# TOWN of BROOKLINE

SUBJECT: High School Expansion Project – Deferred Maintenance  
NB Kenney Change Order No. 4 (FY 21)

RE: Recommendation to approve NB Kenney Change Order 004

## Change Order

Figure 46. Field connection diagram RAUJ 20 to 60 tons

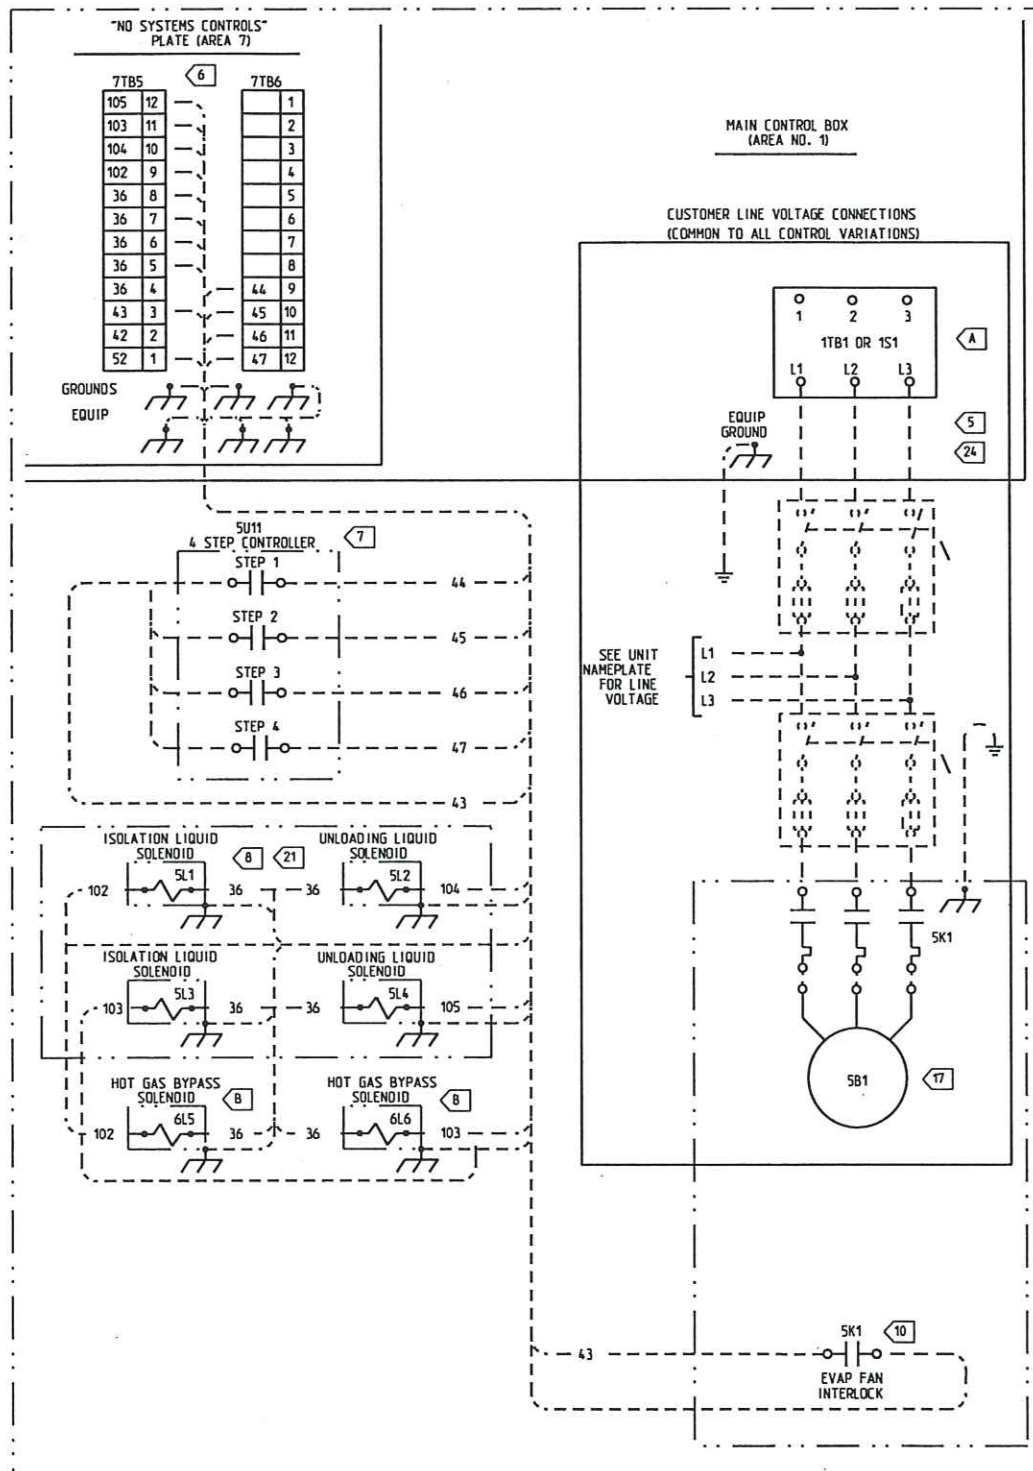
We are hereby submitting the following questions for your response. These issues have potential time and cost impacts. Reference is made to the New Trane Chillers Taged ACCU-6, ACCU-7 & ACCU-8. ACCU-6 is a RAUJ-C30 and ACCU's 7 & \* are RAUJ-C50 units. These new units replaced old existing units. The old unit solenoid valves were 24V, the existing plastic pipe and wire is all for a low voltage application.

Your attention is directed to the attached documents regarding the aforereferenced units, the 1st page is the front page of the Installation, Operation & Maintenance Manual, this is provided so that there is no confusion regarding referenced material. The 2nd attachment page to this RFI is page 66 of this manual; the 3rd and 4th pages are a wiring schematic of the units controls.

The 2nd attachment of this RFI in part pertains to the controls wiring - 115V, there is a list of several items that require 115V power if utilized, the last item in that column is "Liquid line solenoid valve" which requires a 115V connection in lieu of a 24V connection.

The quickest and least expensive to this problem is to install new wire of the appropriate gauge into Cantex Schedule 40 PVC conduit with Cantex fittings and water tight connections. Please review and advise on how we are to proceed with this work.

RFS takes no exception to the NBK proposed solution. Ensure to coordinate all electrical requirements with electrical contractor.
